Technical and Regulatory Guidance for Using Polyethylene Diffusion Bag Samplers to Monitor Volatile Organic Compounds in Groundwater

February 2004

Prepared by
Interstate Technology & Regulatory Council
Diffusion Sampler Team

Response to Technical Comments

Figure 1-2. (right) Comparison of diffusion and pumped samples in groundwater showing relative uniformity in vertical distribution of trichloroethene concentrations in the screened interval of a well (modified from Vroblesky et al. 2003).

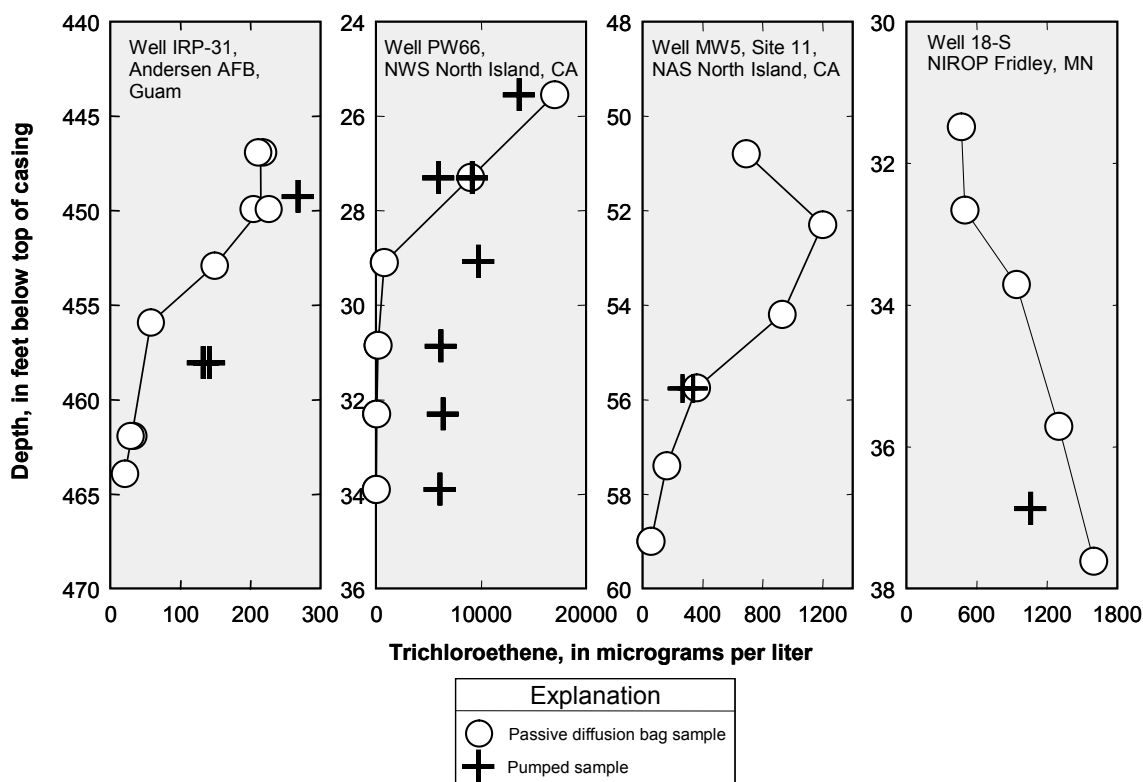
10. P.11, L.11-16: The intent of the discussion regarding Figure 1-2 is not apparent. Either the last sentence should be omitted or the thought process behind the last statement should be clearly presented. As it stands, the discussion provides two possibilities to explain the data in Figure 1-2, then dismisses the second possibility without explanation.

21. Figure 1-2: Statement “The pump produces a mixture of contaminated and uncontaminated water.” This statement also be included in Figure 1-3. While it is true that more of an averaged value is obtained with pumps, this effect is less with PDBs although they don’t seal off a specific zone within a screened interval, particularly in a 4-inch well (PDB diameter is 1.25 inches).

68. Page 3, Figure 1-2: The conclusion(s) that should be drawn from this figure is/are not clear to me. I suggest redrawing it, omitting one of the two curves included, or omitting the entire figure. Simply including a reference to the statement that “contamination stratification has been observed” may suffice.

Figure 4-1. Regulator responses regarding the use of PDBs for various purposes.
(The 54 responses came from 23 different states.)

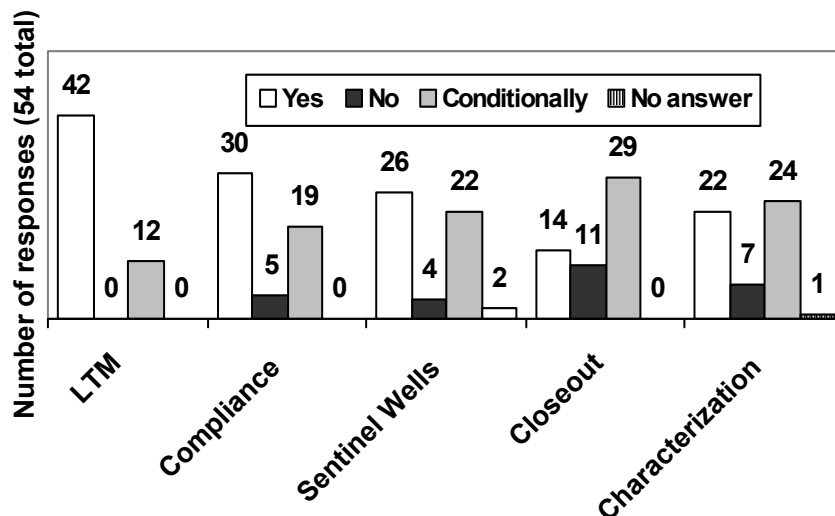
36. Page 36, Line 6: The question asked to be paraphrased and not quoted. Where is the reference to Figure 4-1? Figure 4-1 on page 37 should follow this section on page 36.

This paragraph has been modified and reference to the figures clarified.

Figure 4-2. PDB survey results from 23 states indicating regulator support for specific uses of PDBs.
(Note that the responses reflect not an official state policy but only the proclivity of individual regulators.)

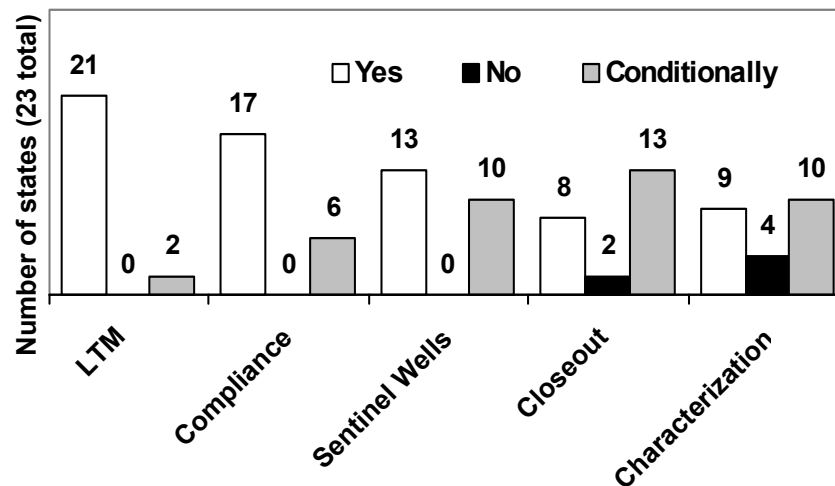
37. Page 38, Lines 5-7 and Figure 4-2: It is misrepresenting the states’ responses to include only one positive response to closeout while a majority may have rejected it.

38. Figure 4-2 Caption: Too many prepositions. Reword “PDB survey results from 23 states indicting regulators acceptability to specific uses. . . .”

There is no best way to condense multiple responses from a given state. The approach taken—to display the response most favorable to PDB sampling—is not a misrepresentation but one alternative that was clearly presented as such. The reader is free to consult the data in Appendix D to conduct his own analysis. The caption for Figure 4-2 has been modified to call attention to the assumptions stated in the text.
